Product Change Notification

PCN No: 2021-04-16-02
Report Date: April 16, 2021
Subject: GTT70A-TPN/TPR Display Change
eGTT70A-TPN/TPR Display Change

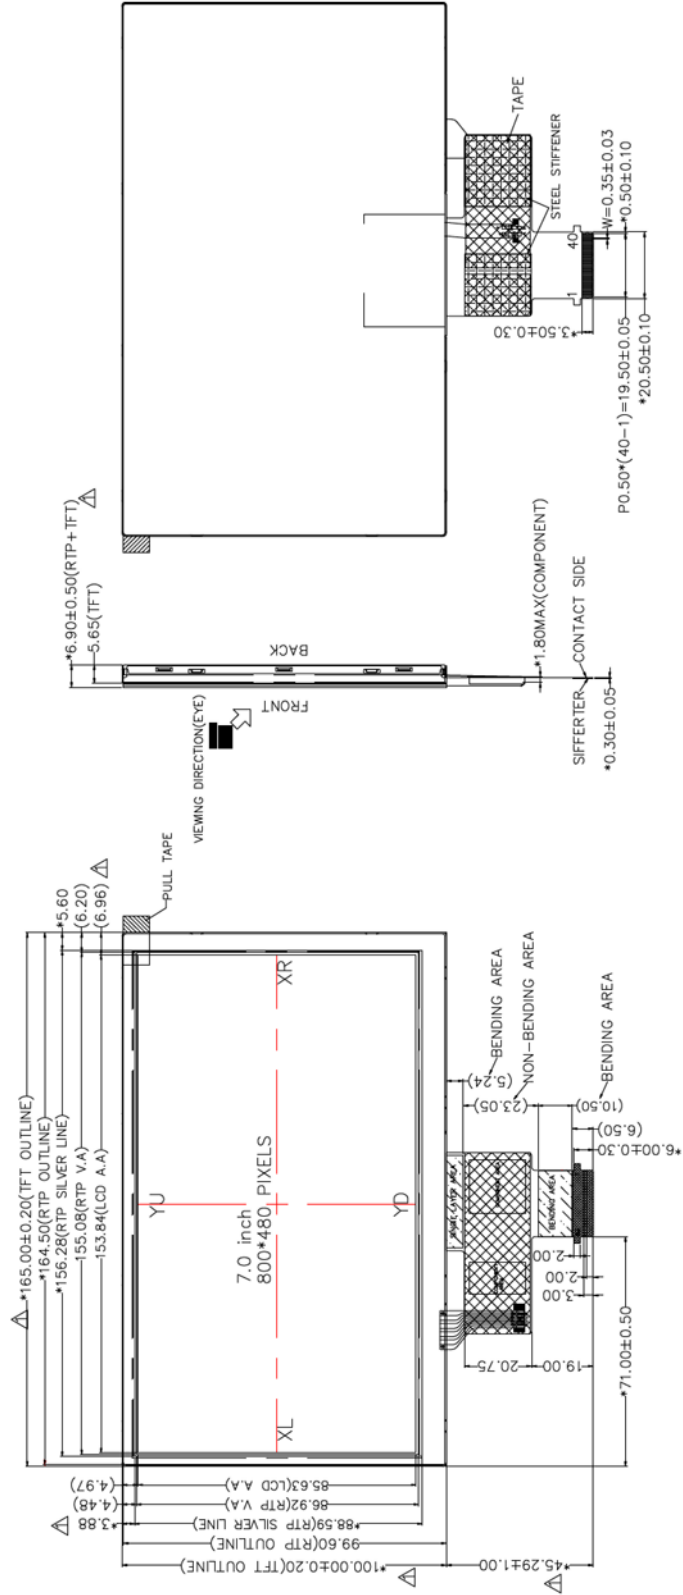
Replacement of 7.0" display panel.

The display mechanically has become thicker with minimal module mechanical change.

Current	New
Module size (L*W*H) mm	164.9 * 100.0 * 3.5	165.0 * 100.2 * 5.6
Active area (L*W)	153.84 * 85.63	153.84 * 85.63
Pixel pitch (L*W)	0.192 * 0.178	0.192 * 0.178
